RE: Letter of Intent – Major Amendment to the Wind and/or Solar Energy Generation Plan Overlay (WSE-O) District (WSEO-20-1)

loi V_2 redline.pdf Markup Summary 9-18-2020

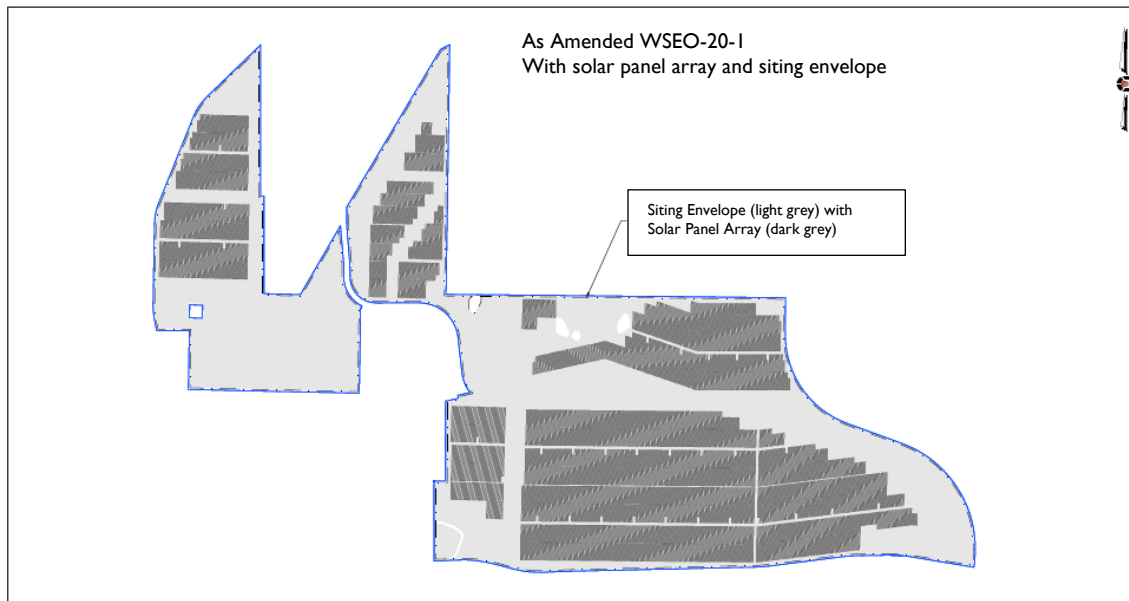
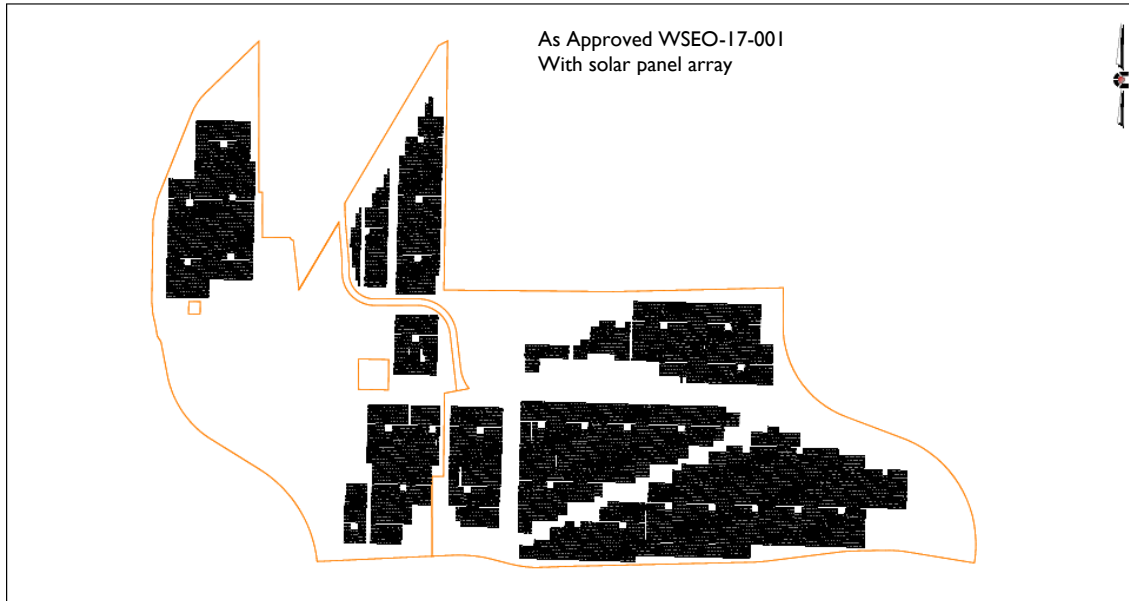
if you do not have
NOW delete
